URGENT - FIELD SAFETY NOTICE**GETINGE VOLISTA StandOP and TRIOP
Field Action MSA-2017-001-IU**

Date:	March 15, 2018
Product Issue:	Potential keypad failure on VOLISTA StandOP and TRIOP Surgical Lights
Affected Product:	All Getinge VOLISTA cupolas of model StandOP and TRIOP made until June 2017 equipped with keypad ARD568801560. The complete list of affected serial numbers for your market are listed in a separate document (Annex 1).
Resolution:	Maquet SAS proposes to replace the keypads ARD568801560 on the devices with keypads of a different design ARD568805501 to make sure all devices present in the market are working effectively and safely
Affected Serial Nos.:	See Annex 1 (consignee list)
Field Correction Notice:	MSA/2017/001/IU
Pages:	3

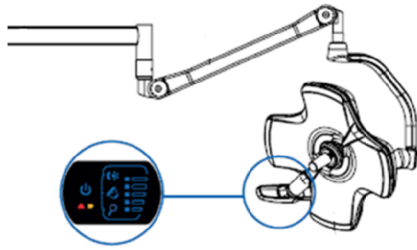
The issue we found can cause a failure of the control keypad. This can result in the cupola not turning on or off. We have received numerous complaints where this problem happened on 3 different keypad versions. From our investigation which includes our evaluation of worst-case scenarios it was concluded that there is only a remote chance that the problem may cause injury. However it is possible.

This potential for malfunction is caused by an internal frequency issue of a component on keypads version 1, and by the touch-sensitive technology that was not sensitive enough on versions 2 and 3 . The keypads at fault are no longer produced. We have implemented a more robust keypad using a different technology. Although the probability of occurrence of harm is low, we want to prevent any related event from occurring with our customers.

This action is to replace the potentially defective keypads with the new ones. The devices involved at your facility are listed in the consignee list file you received for this field action.
